# SERVICE BULLETIN

Service Bulletin #: SB 02

Title: Compact Flash Removal/Replacement.

Figure 1: MFD with Compact Flash Cover Removed

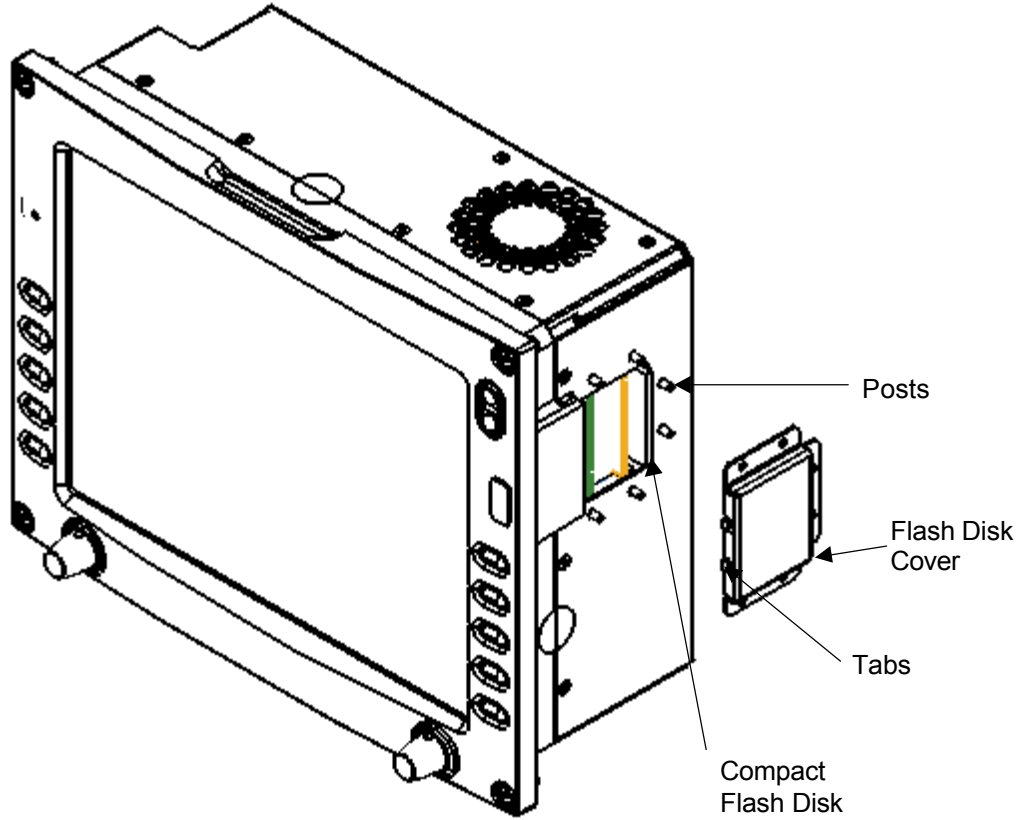
This procedure should be performed on the bench. Ensure NO power is applied to the unit. Refer to Figure 1.

1. Remove the Flash cover by unscrewing the 6 nuts and lifting the cover off the posts.

2. Remove the 530-00112-000 (Rev 00 or Rev 01) compact flash by pulling it from the connector and sliding it out (as shown in Figure 1).

1. Orient the compact flash by locating the red arrow. This indicates which edge of the device slides in first. The compact flash is keyed, so it will only slide in one way. Look for two small indentations on opposite edges of the device. They should be on the side of the compact flash that faces the front of the unit.
2. Slide the 530-00112-000 Rev 02 compact flash into the slot.
3. Ensure the compact flash is fully seated.
4. Replace the compact flash cover.
5. Secure cover with the nuts.
